Attn: Mr. Barry Peterman. Re: File No. 03-10-0044-P.
Permit Application to Construct a Boat Launch (MDNR)
Comments by Dr. Stacy L. Daniels, Crystal Lake Watershed Fund, Inc.

Attn: Mr. Barry Peterman.
Re: File No. 03-10-0044-P.
Permit Application to Construct a Boat Launch (MDNR)

Continuation of comments by Dr. Stacy L. Daniels, Crystal Lake Watershed Fund, Inc.

Figure 1. GIS Map of the Area Surrounding the MDNR Boat Launch (proposed).

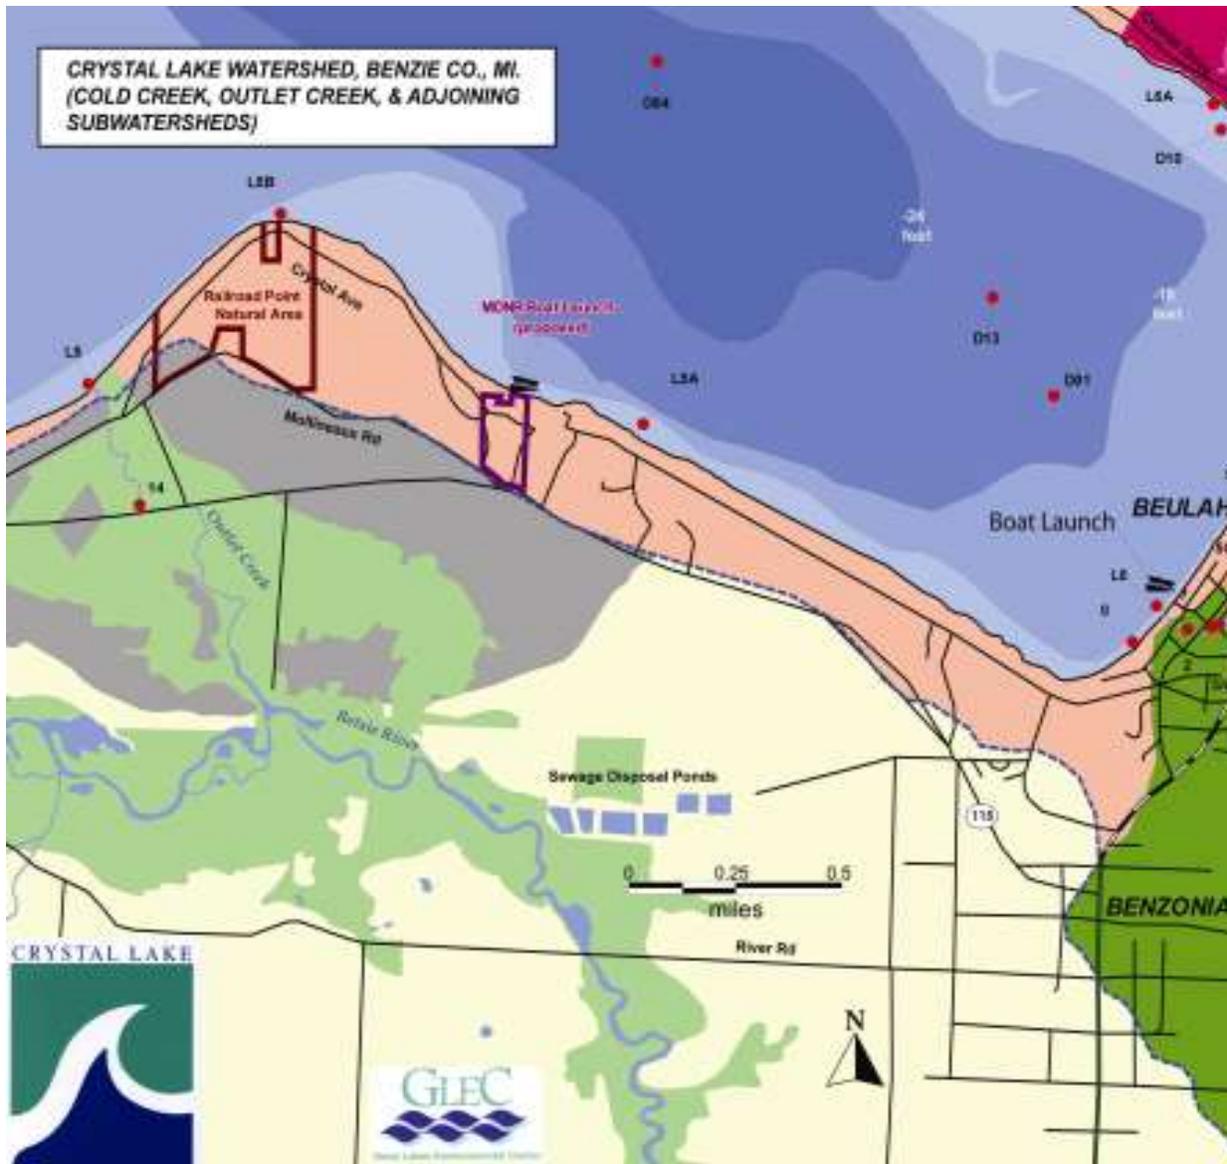
The description of the alternative of offsite diversion can be best illustrated using maps of the area.. A Geographic Information System (GIS) map of the area surrounding the Site of the MDNR Boat Launch (proposed) is contained in Figure 1. The proximity to the Site of the Railroad Point Natural Area, Outlet Creek, the Betsie River, neighboring wetlands; and the Village of Beulah, the existing public boat launch at Beulah, Cold Creek, and the Sewage Disposal Ponds for the Village are shown. The CLWF has identified several nearshore, tributary, and deepwater monitoring locations in the proximity of the Site.

Figure 2. Topographic Map of Southwest Crystal Lake Watershed.

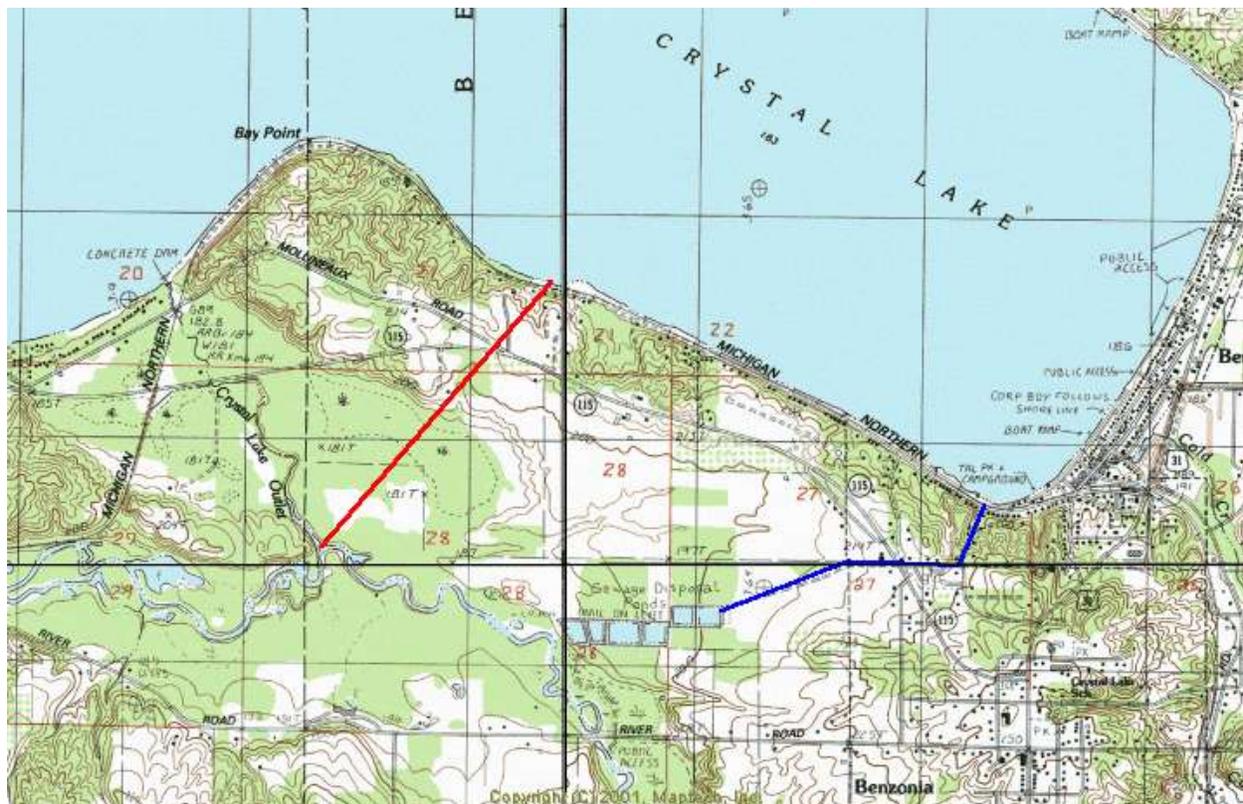
The Site of the proposed boat launch is further outlined in Figure 2 (*). The track traced by the Red Line (left) begins on the Site at the shoreline of Crystal Lake and extends southwest to the mouth of Outlet Creek where it enters the Betsie River. Moving southwest, this track first rises steeply to the ridge separating the Crystal Lake Watershed (north) from the Betsie River Watershed (south). It next crosses Mollineaux Road, then falls to a large wetlands area currently owned by the Grand Traverse Regional Land Conservancy, and finally continues to the Outlet Creek/Betsie River fork. The total distance is about 5,113 feet with a net drop of ~ 100 feet. The distance northeast from the top of the ridge on the SW corner of the Site to the Lake and the proposed boat launch is about 1,300 feet. The distance southwest from the top of the ridge to the neighboring wetlands is also about 1,300 feet.

The Sewage Disposal Ponds for the Village of Beulah are located southwest of the Village, south of Highway M115, and north of River Road. The track traced by the Blue Line (right) begins at Crystal Lake and extends south and west following roads to the Ponds. This track first rises to the ridge between the Crystal Lake and Betsie River Watersheds, and then falls toward the Ponds near the Betsie River. The total road distance is about 4,554 feet with a net drop in elevation ~ 70 feet from Crystal Lake.

Figure 3. Three-Dimensional Map of Southwest Crystal Lake Watershed.

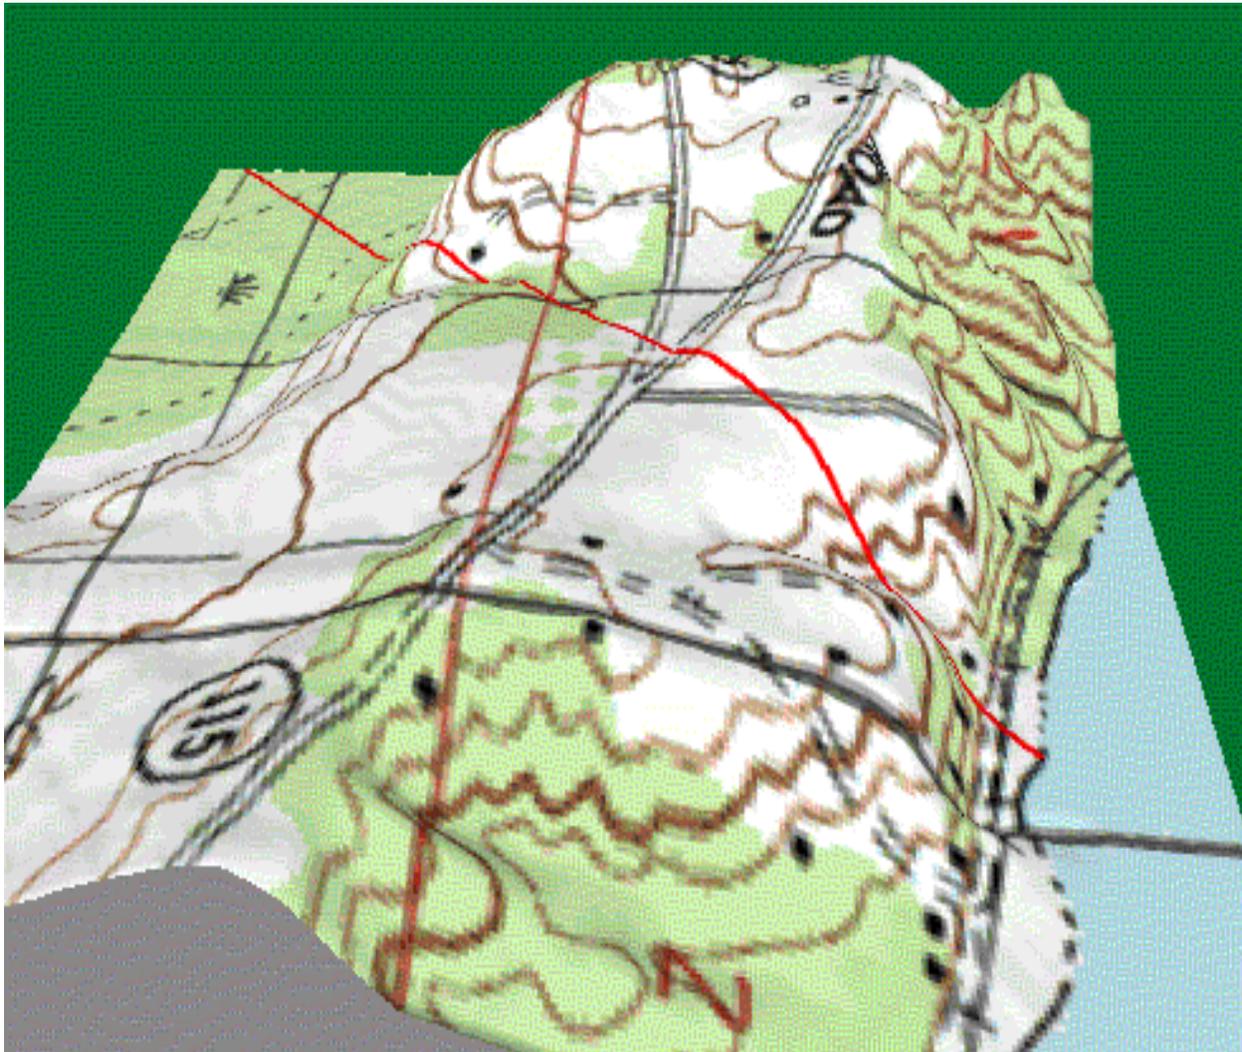
The rise and fall of the track between the shore of Crystal Lake, across the Site, and continuing to the Betsie River, is shown in a three-dimensional view in Figure 3. The ridge delineating the boundary between the Crystal Lake Watershed (north) and the Betsie River Watershed (south) is dramatically illustrated. The steep topographic relief indeed has a “significant impact on the overall site design”.
